VSP - 149  
DATE: December 16, 2002 (M)

**SUBJECT: Distribution of: Kelly Aerospace Service Bulletin No. A-107A**

Bulletin No. A-107A

**SUBJECT:** Inspection of Fuel Regulator Shutoff Valve as Used With Kelly Aerospace Combustion Heaters, Models B1500-B4500

**Figure 2**

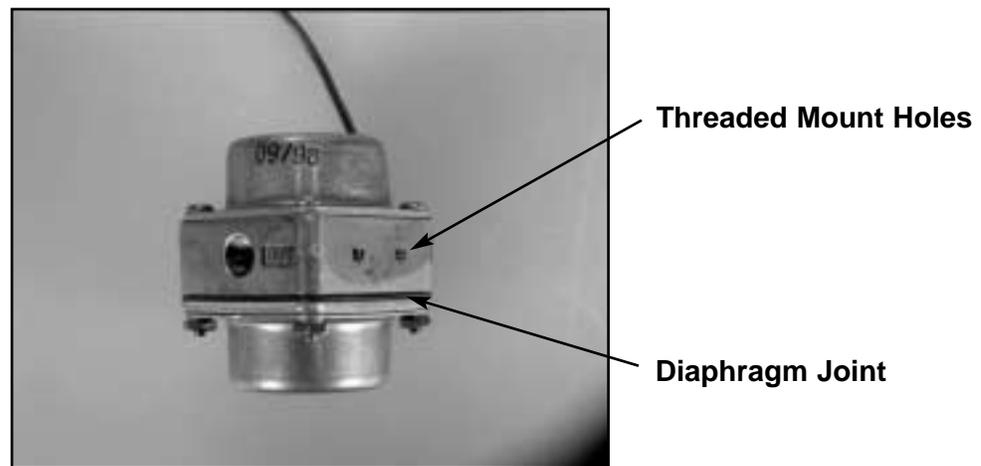
Recent field reports have indicated the possibility of fuel seepage at either the diaphragm joint or threaded mount holes as shown in Figure 2. Within the next 10 hours of operation, inspect the pressure regulator shut off valve for signs of fuel leakage as follows.

- b. Using mineral spirits or JET-A as the test fluid, pressurize the inlet port of the regulator valve to 50 psi for 1 minute minimum with the solenoid energized. Carefully inspect the valve body for signs of fuel leakage giving careful attention to the diaphragm joint and the threaded mount holes as shown in Figure 2. **CAUTION - prior to test, exercise care to wipe valve body and fittings free of any residual fluid that may have contacted external surfaces of the valve during test setup.** Leakage may appear as a wetness or seepage at the diaphragm joint or threaded mount holes. Rotate the valve during pressure test as necessary to fully inspect all external surfaces.

- 5) Visually inspect the valve body for signs of fuel stains, paying careful attention to the diaphragm joint and the threaded mounting holes located in sides of the valve body (see Figure 2). Fuel leakage in those applications using AVGAS may appear as a greenish blue stain or residue in the area of the diaphragm joint or threaded mount hole. Fuel leakage in those applications using JET-A fuel may appear as a wetness or oily residue at the diaphragm joint or threaded mount hole. Utilize supplemental lighting if needed to facilitate visual inspection. Visual inspection must include all four sides of the regulator valve body. If signs of fuel leakage are found replace the valve using a new valve of appropriate part number with a manufacture date code of 02/02 or later. Record valve replacement and Service Bulletin compliance in the logbook.

- c. If signs of fuel leakage are found replace the valve using a new valve of appropriate part number with a manufacture date code of 02/02 or later. Record valve replacement and Service Bulletin compliance in the logbook.
